Date of Issue: April 2022

Affected Publication: API Specification 11D1, Packers and Bridge Plugs, Fourth Edition, March 2021

Addendum 1

Figure 2: The figure shall be replaced with the following:

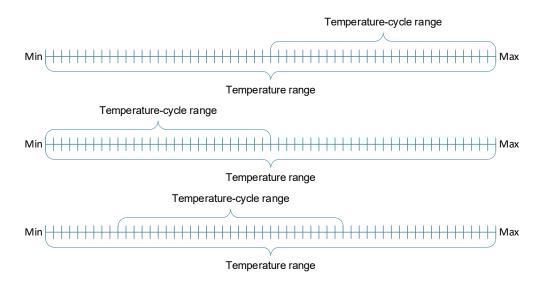
Section 6.3.4.3: In the opening paragraph, the definition cross references shall be updated as indicated in the red boxes:

Figure 2 is an illustration of the temperature-cycle range (see 3.33), which is the temperature change over which the product is designed to operate, and the temperature range (see 3.34), which is the range of temperature over which the product is designed to operate.

Section 6.3.4.3: The following shall be added after the opening paragraph:

There shall be only one rated temperature-cycle range and only one rated temperature range for a validated product. If the product cannot be successfully validated using one temperature-cycle range that covers the product's entire temperature range, multiple successful tests shall be performed that cover the maximum

and minimum temperatures of the product's temperature range. The rated temperature-cycle range of the product is the smallest of the validated temperature-cycle ranges.
